TO: Town of Parker Recreation Dept.
FROM: Julia Duncan, Associate Planner
DATE: January 23, 2025
SUBJECT: SP24-124; Salisbury North MDP F1 AMD 2 L1 - Park Expansion Phase 1
Review Comments 01

SALISBURY PARK NORTH PHASE 1

TOWN OF PARKER SITE PLAN

Drawing
HEADQUARTERS &
COMMUNITY HUB
PAVILION 3D VIEWS

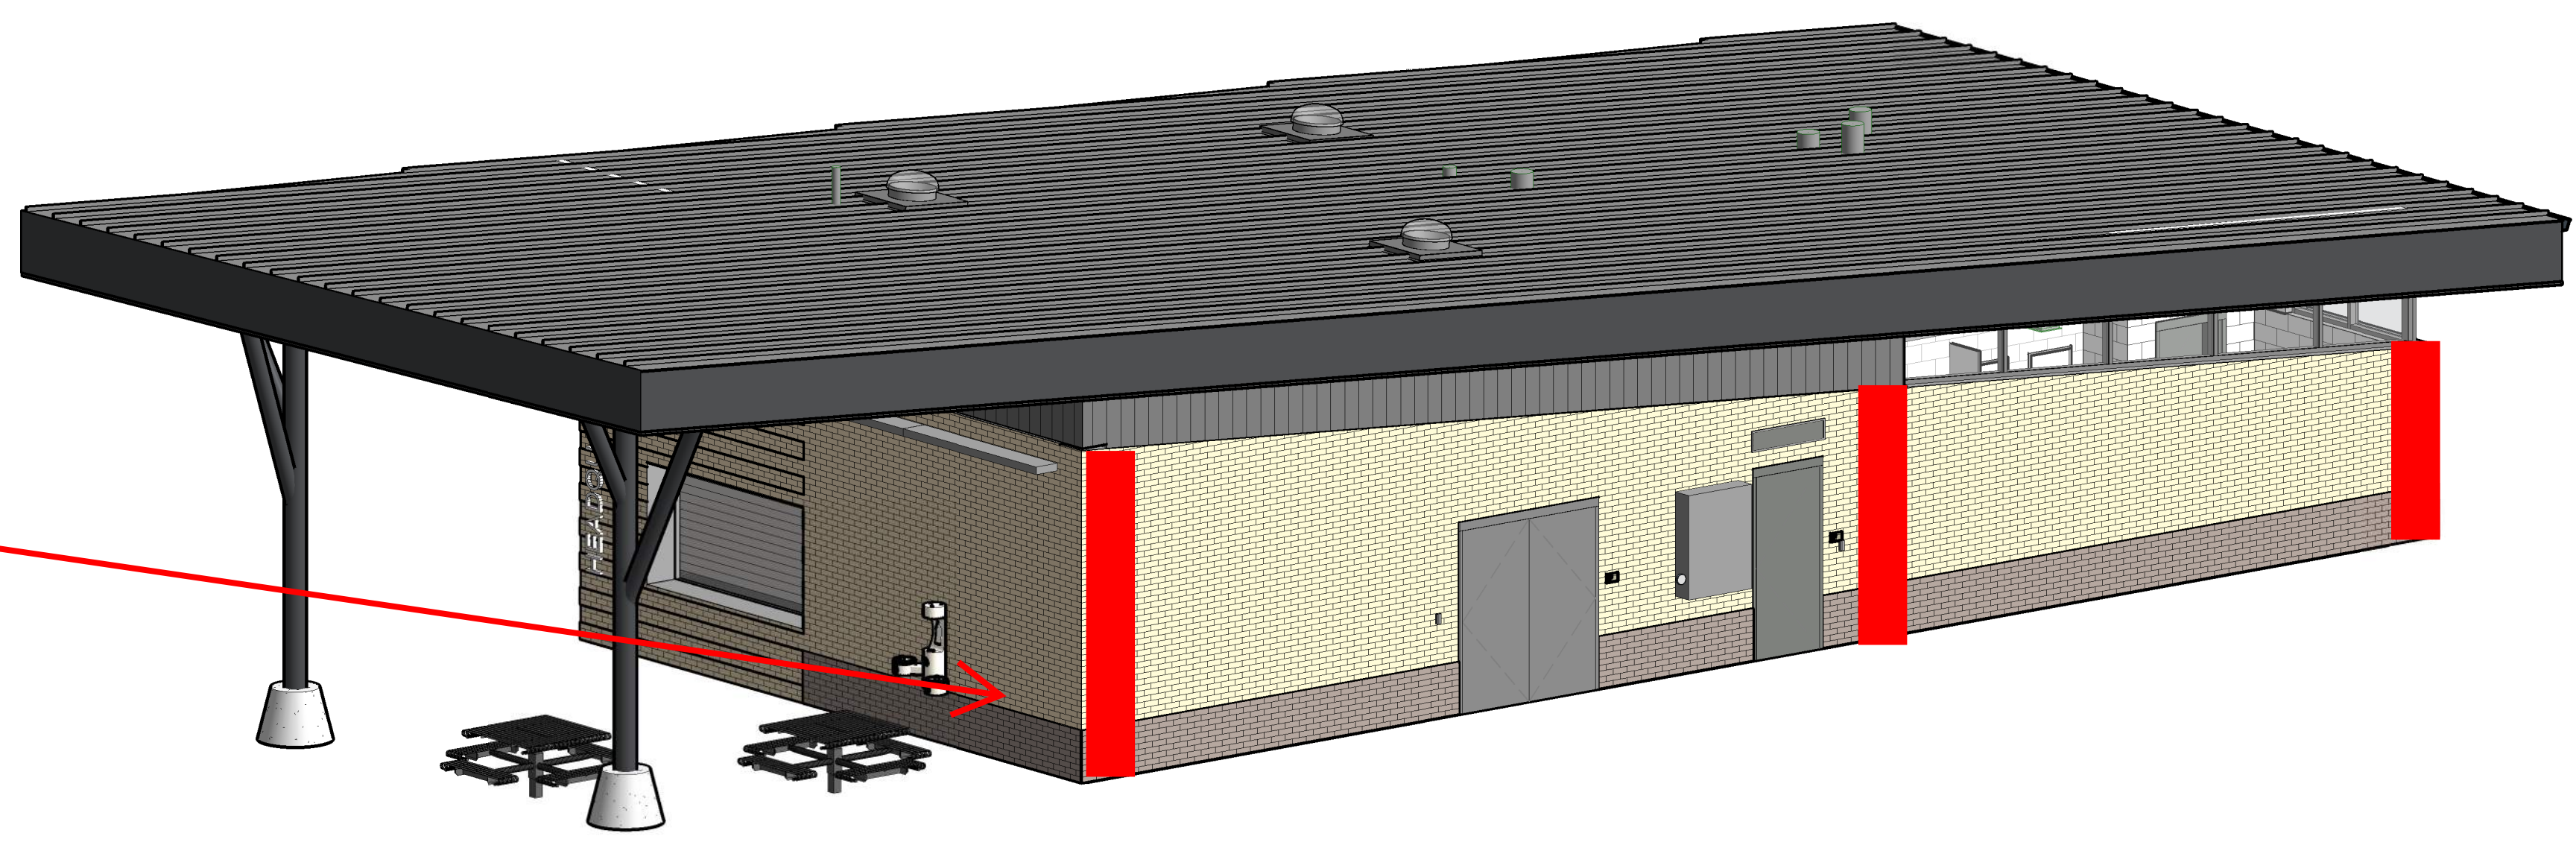
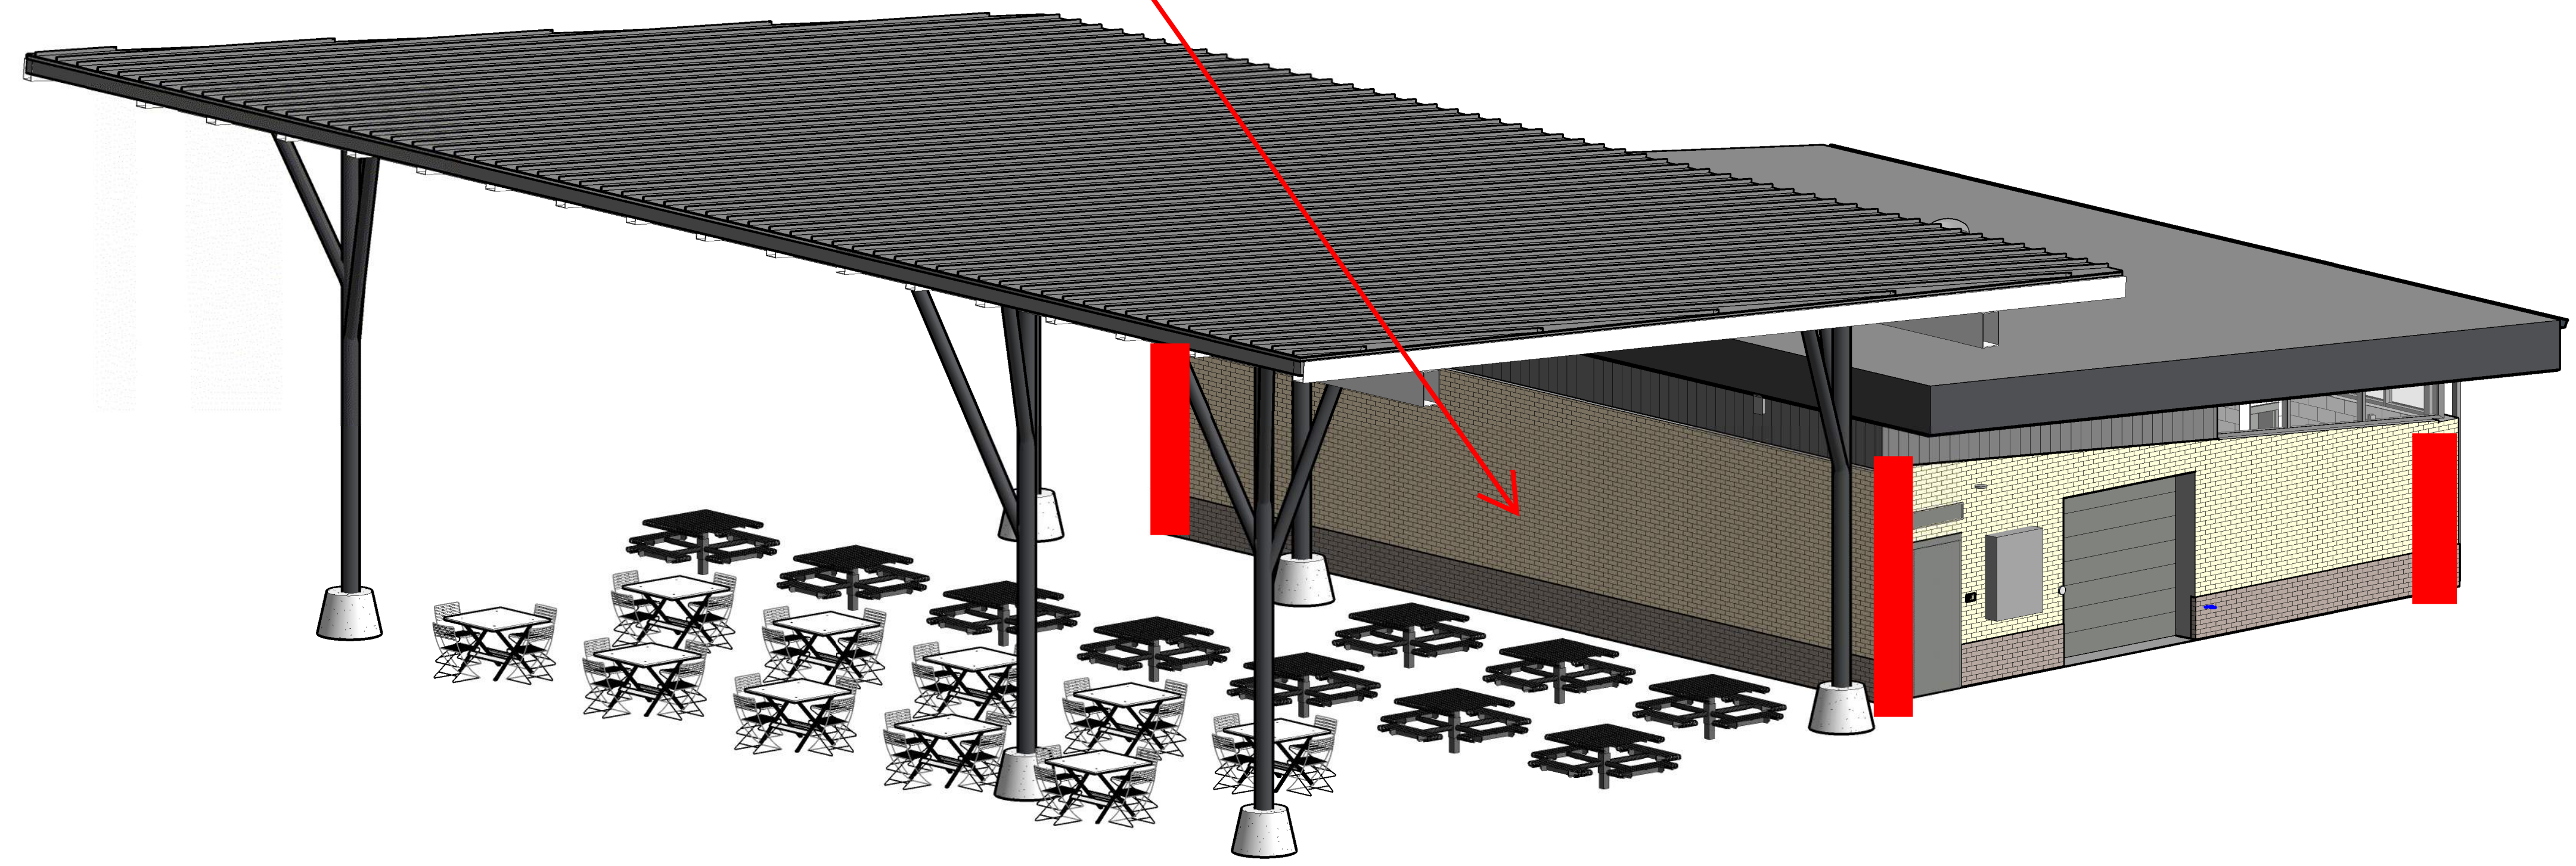
Incorporate vertical column elements on corners to break up
building as well as additional art/graphics

These are just examples/suggestions but bring the darker brick
element up at intervals and have it protrude to create plane
breaks

Brick banding was added to both buildings to emulate
the vertical plane breaks. The proposed design solution
was presented to Julia Duncan and was reviewed and
approved by the planning staff. All new banding is incorporated
into the revised elevations. - HCM
